REMARKS

Applicant : Jeffrey A. Anderson
Serial No. : 10/633,694
Filed : August 5, 2003
Page : 12 of 13

AMENDMENTS TO THE DRAWINGS

FIG. 3

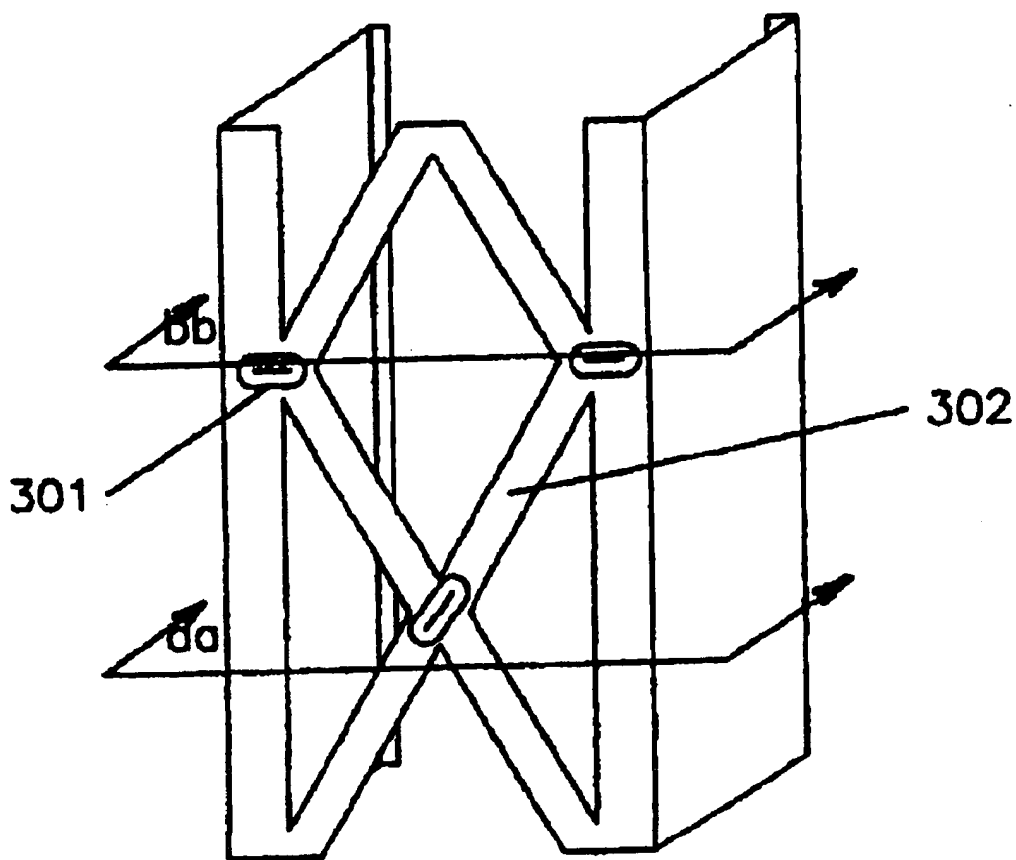
The specification and page 2 of the drawings as filed have been amended for technical clarity. The specification previously identified flange 302. In fact, reference numeral 302 refers to a web element, and the specification and FIG. 3a have been amended accordingly to more clearly identify web element 302 and flange 303. Applicant submits that these technical changes are fully supported in the as-filed application. See, e.g., FIG. 1; specification at page 5, line 17 - page 6, line 5 (reference numeral 102 identified as web element). Entry of this amendment is respectfully submitted.

In FIG. 3a, reference numeral 303 identifying strengthening flange 303 has been added, as indicated in the attached copy of the original sheet including changes marked in red ink.
